INTER-DEPARTMENTAL COMMUNICATION PROJECT CONDITIONS AND COMMENTS

Project Address: 1233 S. Glendale Avenue	Project Case Nos.: PVAR 2108841, PPRP 2108839
-----------------------------------------------------------	----------------------------------------------------------------

SUBJECT: PVAR 2108841 & PPRP 2108839
1233 S Glendale Avenue, East End Studios

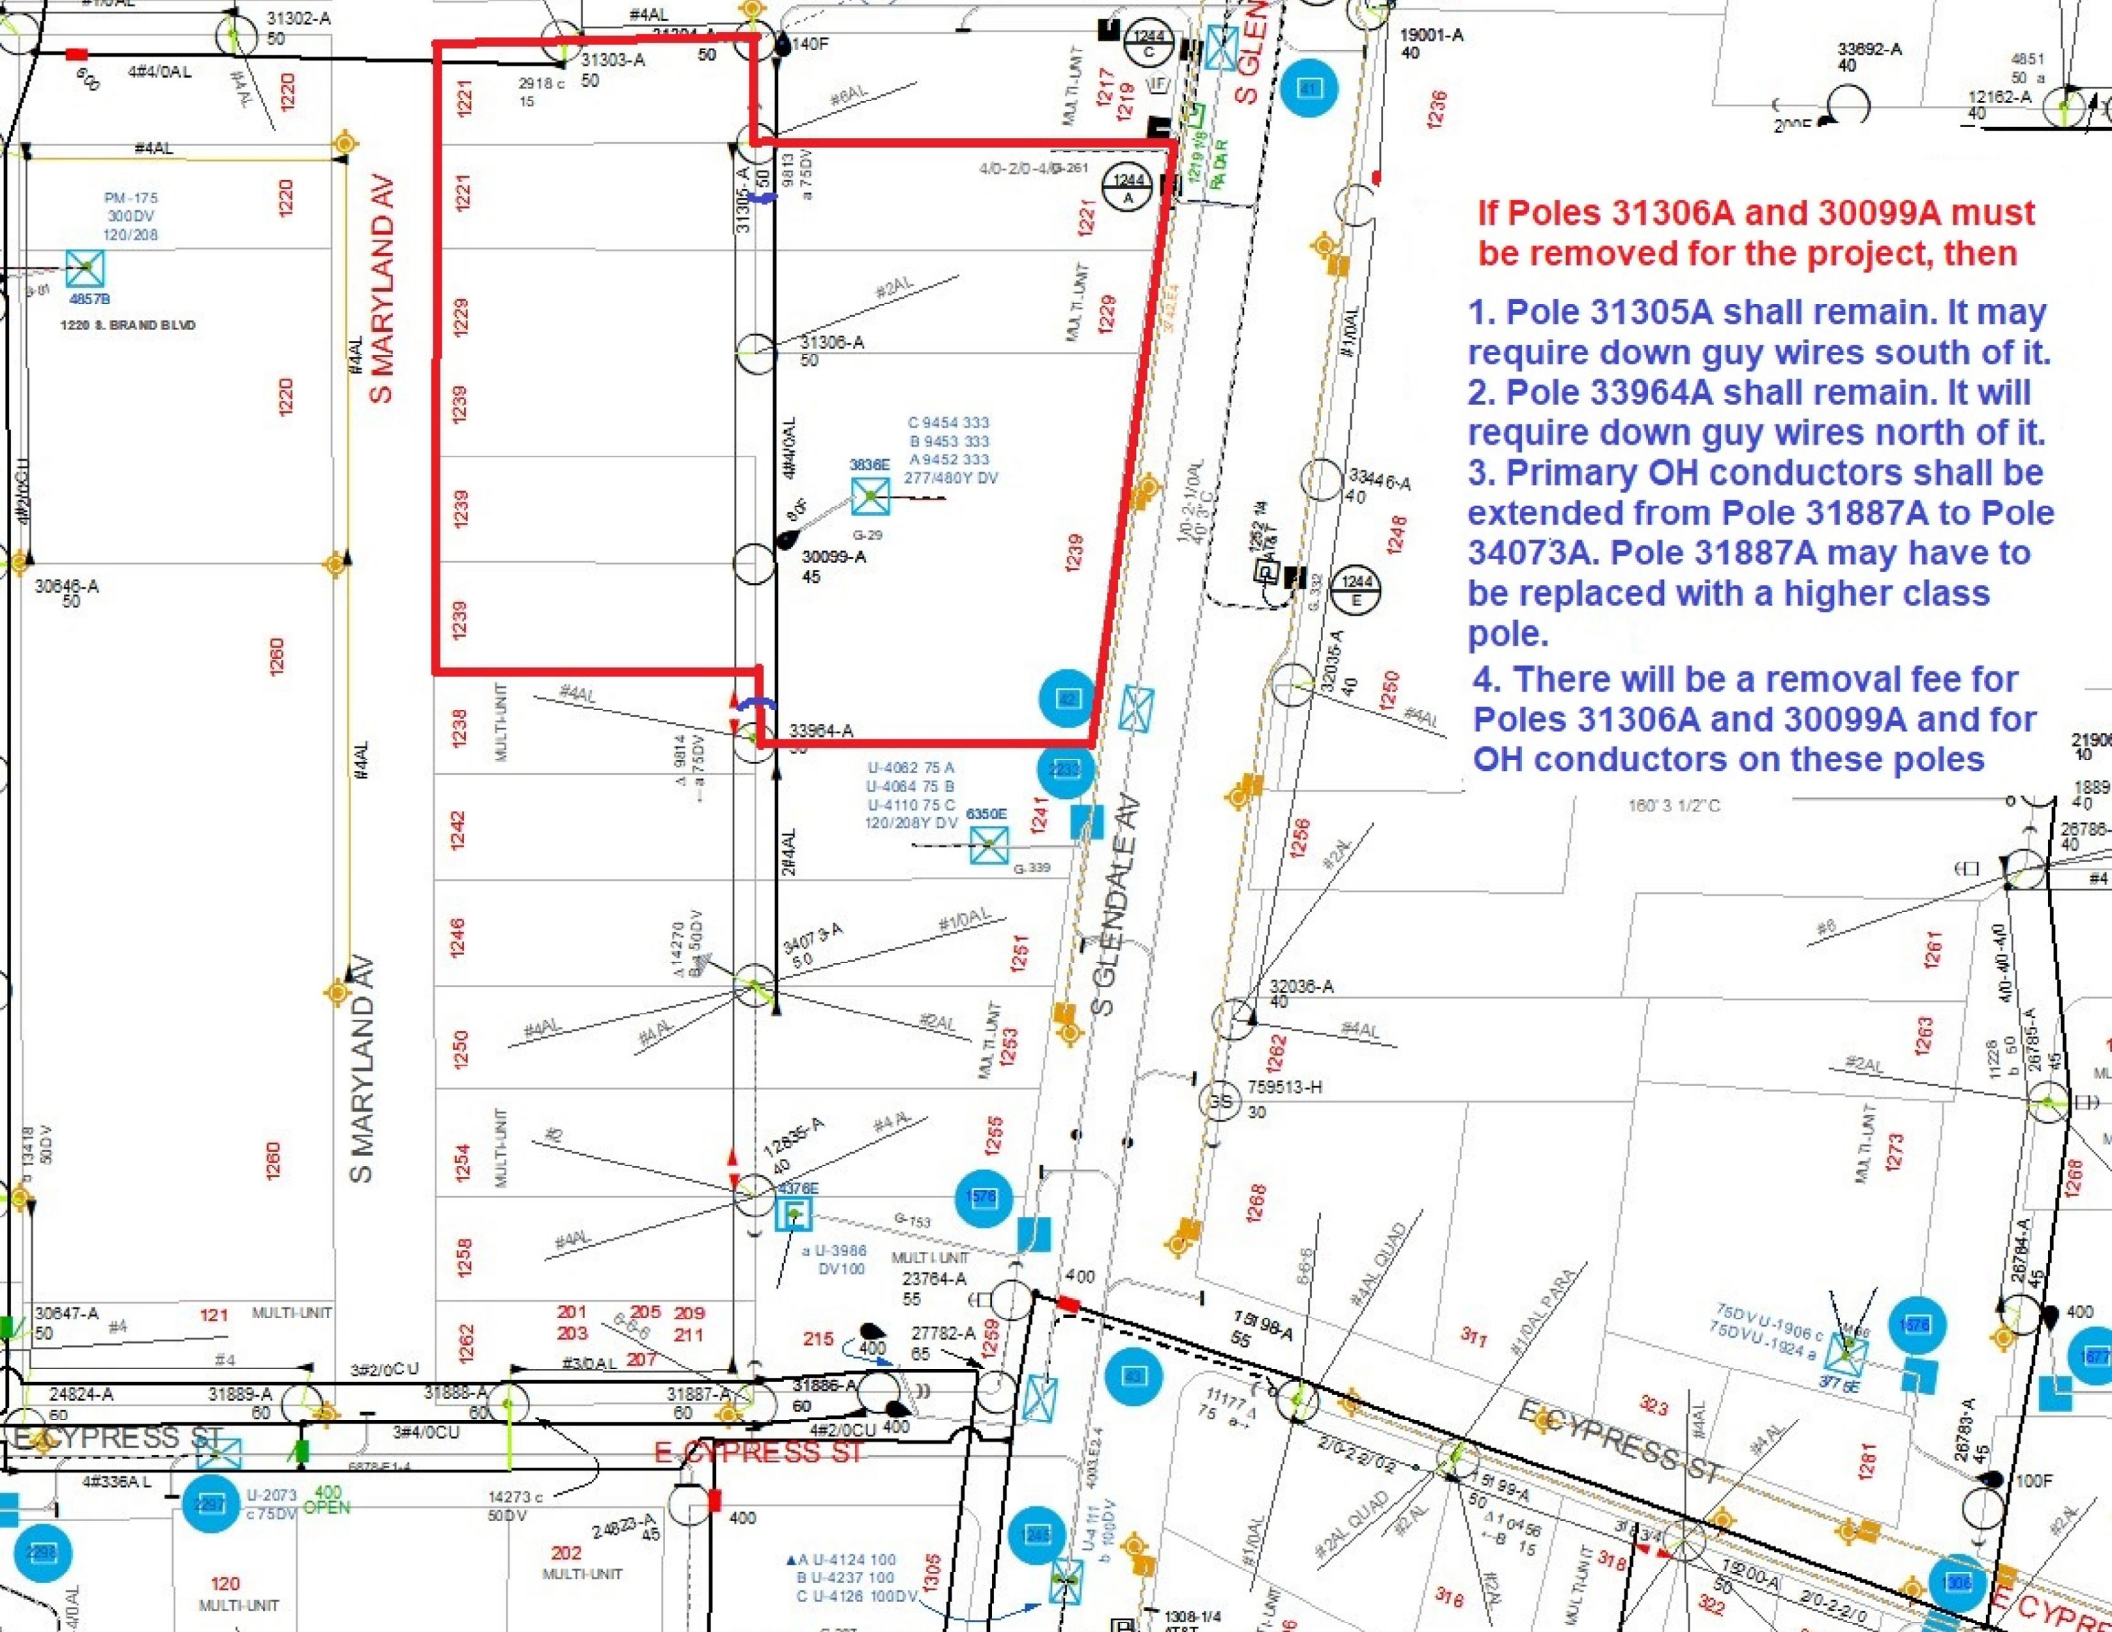
- Any possible power pole relocations shall be coordinated with GWP Electrical Engineering in advance at the project's expenses.
- The proposed development/project conflicts with the existing power poles and/or overhead conductors. Contact GWP Electrical Engineering Department for more information.
- Additional comment(s) and/or attachment(s).
Contact GWP engineering to discuss the project details related to the power poles in the project area. Which poles are required to be removed and which ones can stay? GWP charges to the project will vary depending on the above mentioned. A sketch of the project area will be sent to the Plan Check requester with some notes regarding the removal of the poles.

If Poles 31306A and 30099A must be removed for the project, then

1. Pole 31305A shall remain. It may require down guy wires south of it.
2. Pole 33964A shall remain. It will require down guy wires north of it.
3. Primary OH conductors shall be extended from Pole 31887A to Pole 34073A. Pole 31887A may have to be replaced with a higher class pole.
4. There will be a removal fee for Poles 31306A and 30099A and for OH conductors on these poles
